MEMORANDUM TO:	John L. Pilipchuk, LG, PE State Geotechnical Engineer
FROM:	Ben D. Lackey Jr, PE CATLIN Senior Geotechnical Engineer
STATE PROJECT: F.A. NUMBER: COUNTY:	40238.1.4 (U-4902D) NHS-0017(76) NEW HANOVER
DESCRIPTION:	US 17 Business (Market Street) from Lendire Road to Marsh Oaks Drive
SUBJECT:	Geotechnical Report Addendum – Ground Improvement

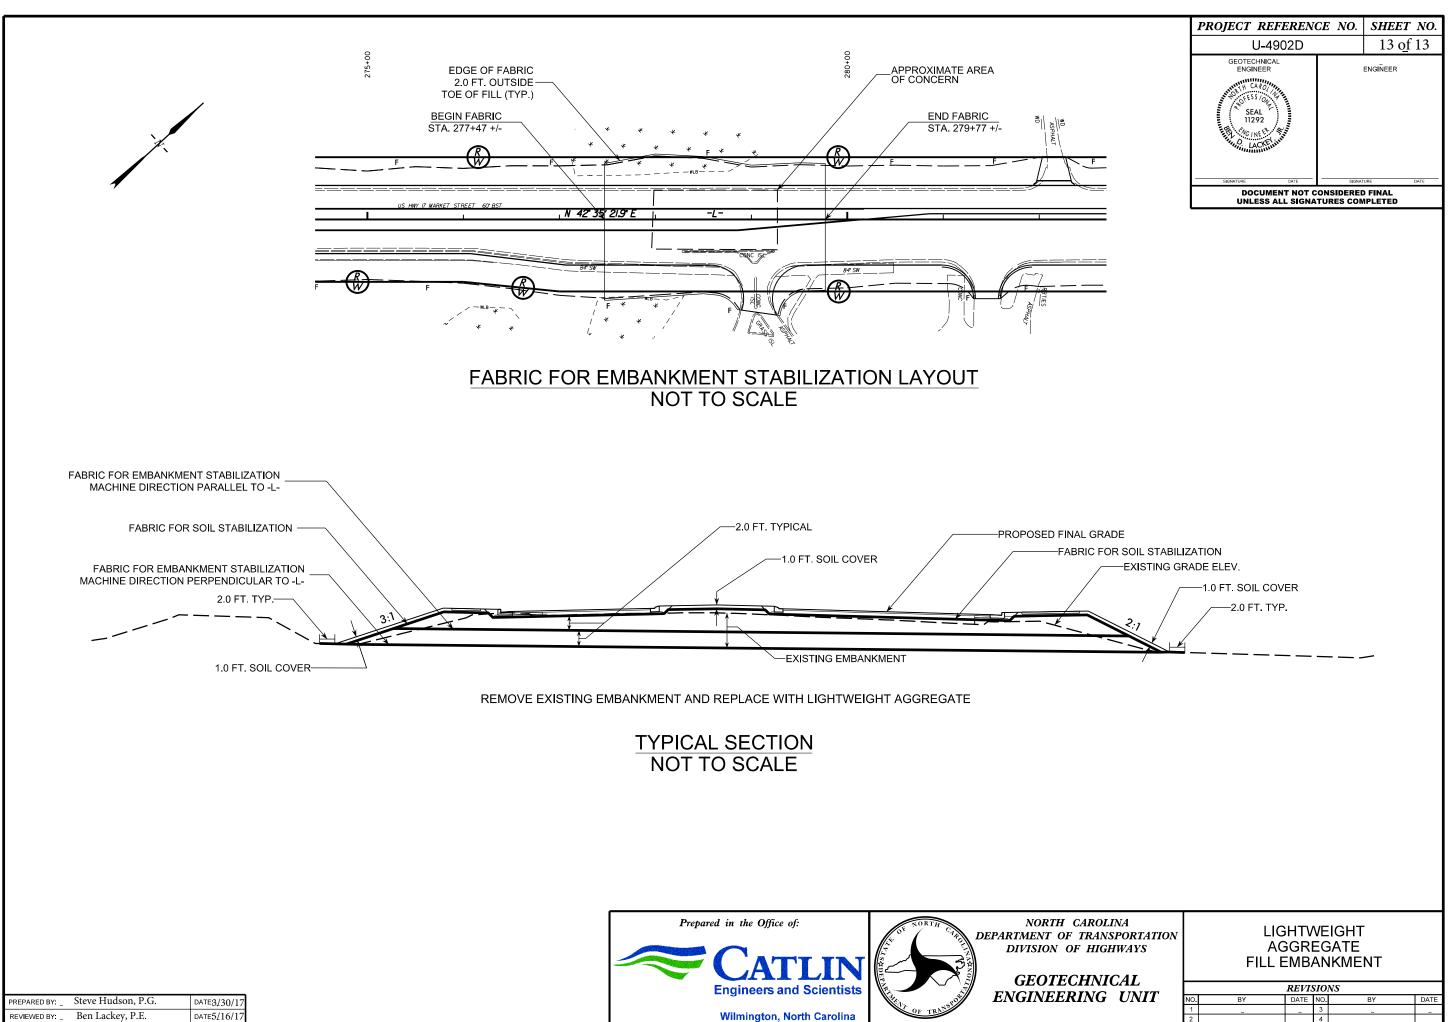
CATLIN recommends the use of lightweight aggregate embankment with high strength fabric for embankment stabilization for the proposed roadway embankment and as a replacement for the existing roadway embankment in this area.

The fabric for the embankment stabilization shall be installed in the following area, as shown on the detail plan, prior to placement of the lightweight aggregate embankment fill. Fabric for embankment construction shall meet the requirements of the attached "Fabric for Embankment Stabilization" special provision. Recommend a quantity of 3,650 square yards of Fabric for Embankment Stabilization in the contract.

The fabric for soil stabilization shall be installed between the lightweight aggregate embankment. Include 7,300 square yards of Fabric for Soil Stabilization in the contract to be used in the following sections, as shown on the detail plan.
